# Planning Development Management Committee Detailed Planning Permission

**161098/DPP:** Change of use from existing park to car park with raised barrier access at Gilcomston Park Car Park, Aberdeen.

For: Skene Investments Ltd

**RECOMMENDATION: Refuse**

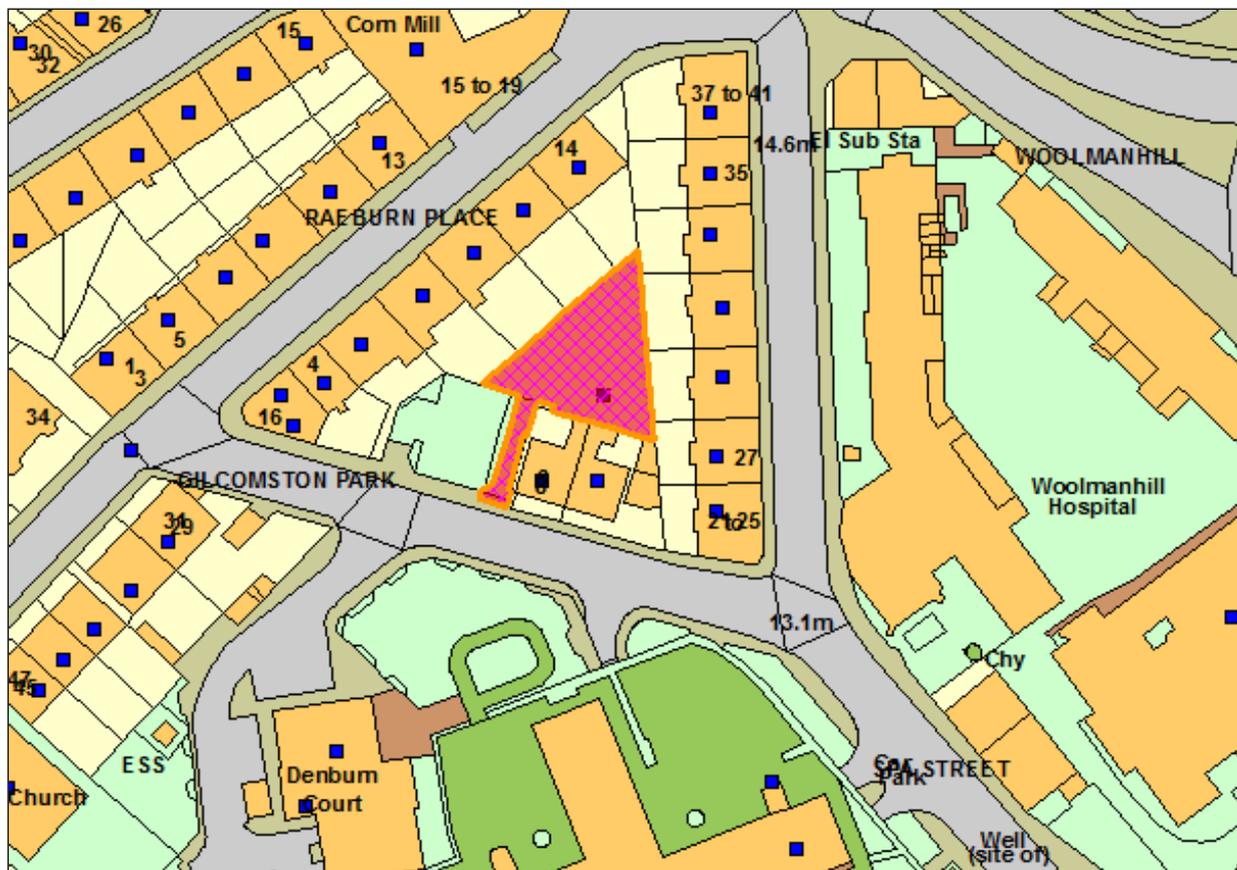
The width of the existing/ proposed access is particularly long and narrow (16.6 metres in length, 2.5 metres in width at its closest point; 2.8 metres at its widest). Whilst it is considered wide enough to accommodate a standard car, it is not wide enough to allow pedestrians safe passage to and from the car park whilst occupied by a moving vehicle, resulting in a potential safety issue.

The entrance to the proposed parking area within the site is considered to be unsatisfactory due to the angle of approach in relation to an existing high granite wall on the eastern boundary of the access, resulting in poor visibility of a large section of the site. This raises a safety concern in that, should the carpark be full, a vehicle entering the site would not be made aware of this until it had travelled the full length of the access and entered the car park itself, following which it would either have to reverse back down the narrow access onto Gilcomston Street with very limited visibility, potentially conflicting with pedestrian movements, or move into the car park, turn around and exit again, the manoeuvrability of which would be difficult as a result of the general parking layout whilst the car park is fully occupied.

Car parking space '1' would not have a full 6 metre aisle width behind it, therefore, this space is not considered to be viable and manoeuvrability into the space would

be difficult. Given the angle of approach, the spaces numbered '1' and '2' would be difficult to access. For example, a car is shown parked forward in space 1 on the submitted layout. This would require significant degree of manoeuvring, which would temporarily block the car park for other users.
